AERIAL FLARE SURVEY & INSPECTION

Activity: Aerial Inspection of Flare Stack and Tip

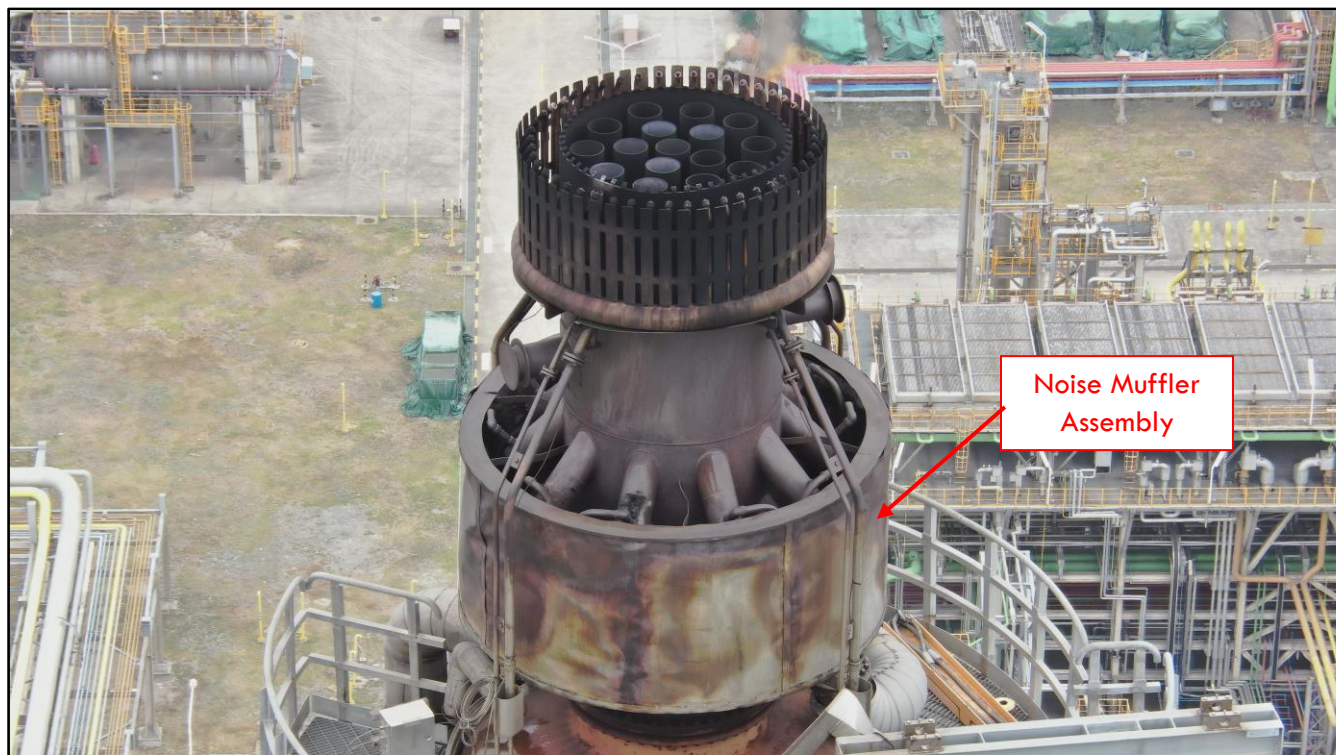
FIGURE 02 – Flare tip assembly should be replaced at the next opportunity. Significant internal burning has occurred in the flare tip noise muffler, smokeless capacity has been compromised, only (1) pilot is functioning, and no combust is occurring.

FIGURE 03 – Perimeter steam injection appears to be in fair condition. No deformation is detected on the upper flare tip barrel. Soot deposits are observed on the windshield assembly.

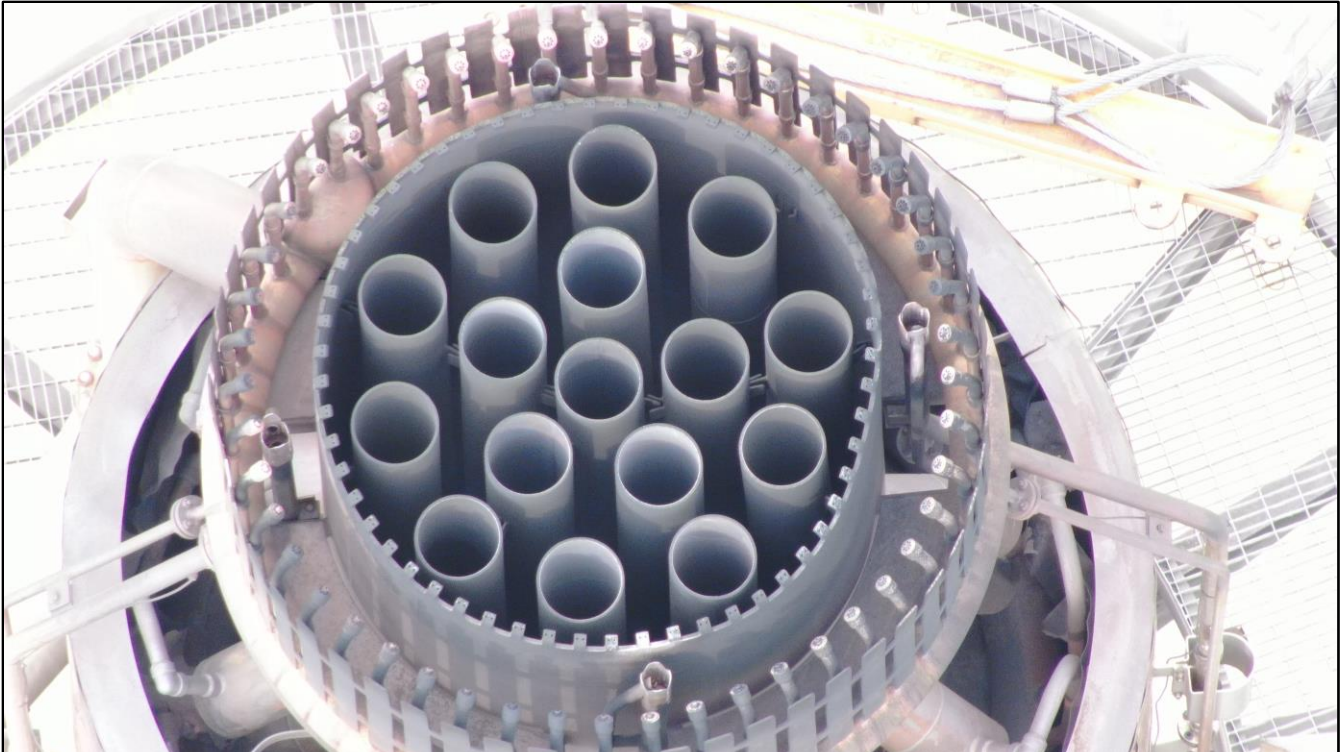
FIGURE 04 – Perimeter steam injectors, steam tubes, flame tabs and pilots all appear to be mechanically intact from an overhead view. The flare tip exit does not appear to have experienced significant heat or combustion, which is an indication that venting has been occurring.

FIGURE 05 – A hole was detected in the steam tubes. Smokeless capacity has been compromised.

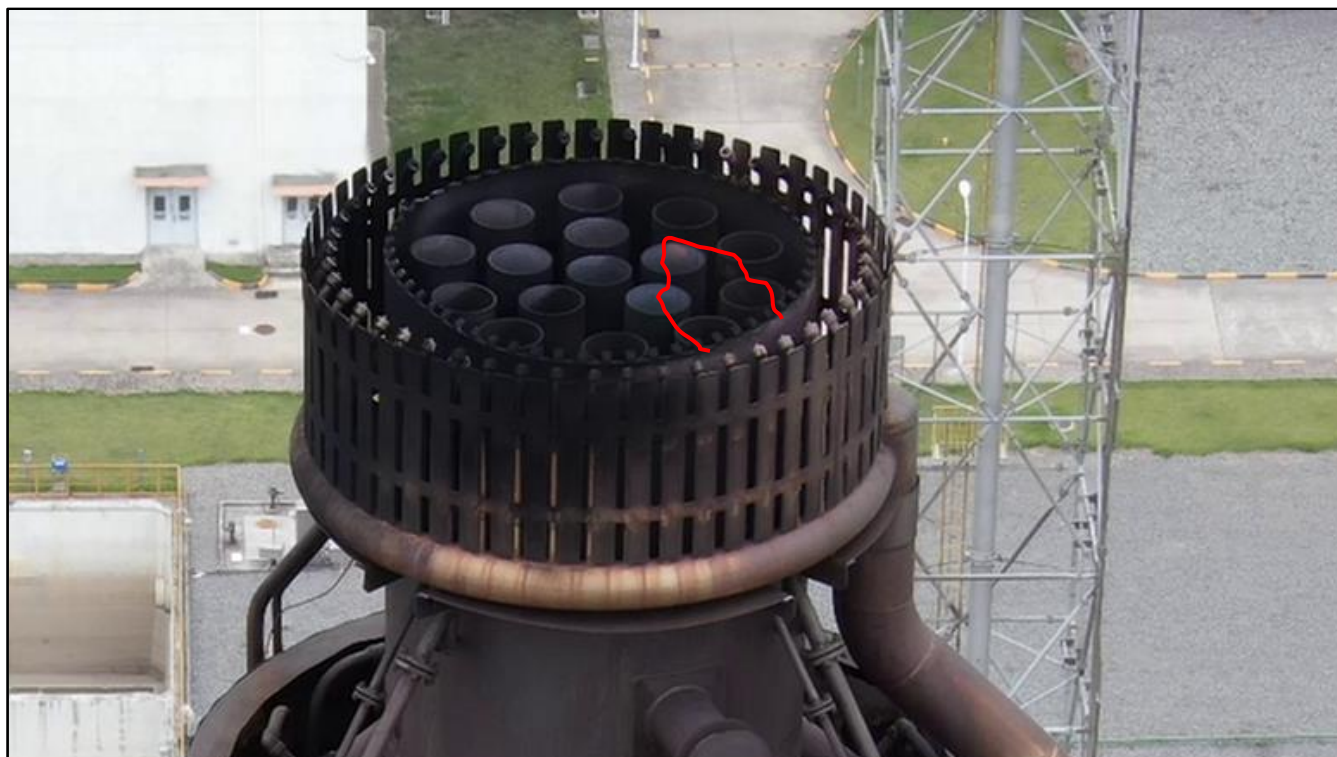
FIGURE 06 – Only (1) pilot appears to be working, and a long yellow flame is seen exiting from the pilot tip. Pilot flame should be blue in color and contained within the pilot hood. This operation indicates pilot instability. Ensure Flame Front Generator (FFG) fuel gas and air is shut off unless pilot ignition is occurring.
